GE Nuclear Energy

Subject: Revision to 8/4/98 Application - Model SRP-1 Package

Reference: Application, S.P. Murray to C.R. Chappell, 8/4/98

GENERAL ELECTRIC COMPANY	
SRP-1 SHIPPING CONTAINER (55 GALLON CAPACITY)	
GENE	0025E98

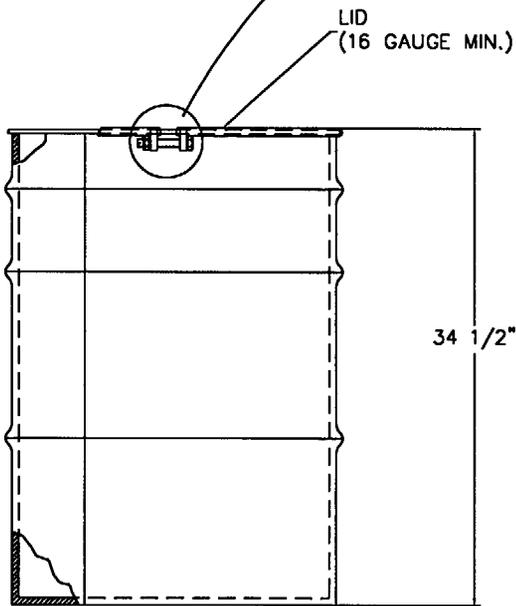
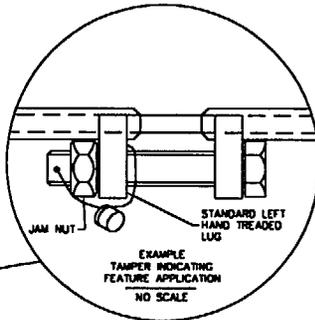
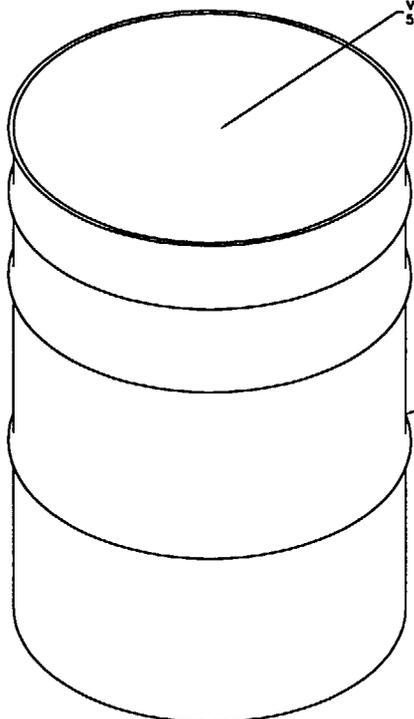
GE drawing 0025E98 has been revised (Revision 1) to reflect the maximum gross weight of 825 lbs. in Note number 7.
